# Access Compliance Report

## Public Rights-of-Way

Intersection ID: 30468	Main Street: GOLDEN_VIEW_DR	Cross Street: OWLS_PERCH_DR	Location: SW
ADA ID: B1B072D8399E	Ramp Type: PerpDiag	Initial Pass/Fail: Fail	Overall Compliance: No
Severity Score: 8.75			
Codes/Mitigation Info/Possible Solution		Field Measurements/Component Compliance

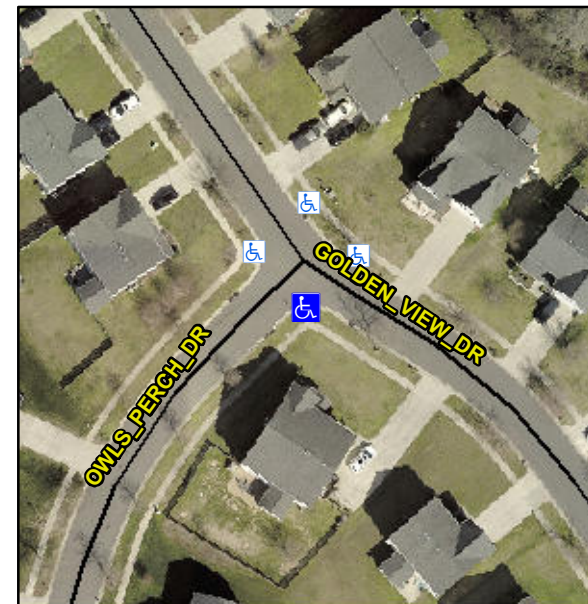
**Not Found, R304.5.1**

Compliance	Description	Data	Compliance	Description	Data
N/A	Ramp Length (in)	84.0	Yes	Ramp Slope (%)	7.0
No	Ramp Width (in)	42.0	Yes	Ramp XSlope (%)	0.0
N/A	Flare Type LT	N/A	N/A	Flare Type RT	N/A
N/A	Flare Slope LT (%)	N/A	N/A	Flare Slope RT (%)	N/A
N/A	Flare Traversable LT?	N/A	N/A	Flare Traversable RT?	N/A
N/A	Landing Length (in)	N/A	N/A	DWS Provided?	N/A
N/A	Landing Width (in)	N/A	N/A	DWS Contrast?	N/A
N/A	Landing Slope (%)	N/A	N/A	DWS Length (in)	N/A
N/A	Landing X Slope (%)	N/A	N/A	DWS Full Width?	N/A
N/A	Landing Curb? (Y/N)	N/A	N/A	DWS Offset (in)	N/A
N/A	Shared Landing?	N/A			
N/A	Gutter Ponding?	N/A	N/A	Gutter Slope (%)	N/A
N/A	Gutter Lip Ht (in)	N/A	N/A	Gutter X Slope (%)	N/A
N/A	Painted X Walk1?	No	N/A	Painted X Walk2?	No
	X Walk 1 Direction	To NE		X Walk 2 Direction	To NW
N/A	X Walk 1 Width (in)	N/A	N/A	X Walk 2 Width (in)	N/A
	X Walk 1 Slope (%)	2.0		X Walk 2 Slope (%)	1.1
	X Walk 1 X Slope (%)	0.9		X Walk 2 X Slope (%)	3.2

**Remove & Replace Curb Ramp With Two New Directional Ramps or Equivalent.**
